U.S. Environmental Protection Agency Comments to MDEQ
regarding draft 2018 Assessment Methodology
July 19, 2017

Comments on Michigan 2018 Draft Integrated Report Assessment Methodology, placed on public notice
June 14, 2017:

Figure 4.4. Determination of fish consumption designated use support using water column mercury concentration.

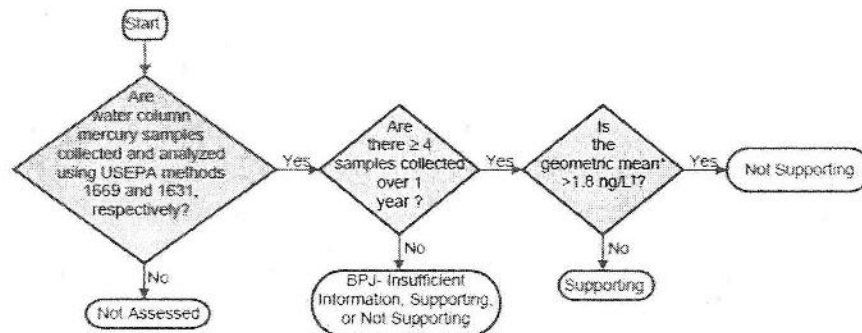
3. Section 4.8.1.1 [Water Column and Fish tissue Mercury Concentrations], Figure 4.4, at the third decision point (diamond): "Is the geometric mean* > 1.8 ng/l+?", use of * and + indicates there are notes associated with this sentence but we were unable to locate the notes. If there are no notes, please remove the note indicators.
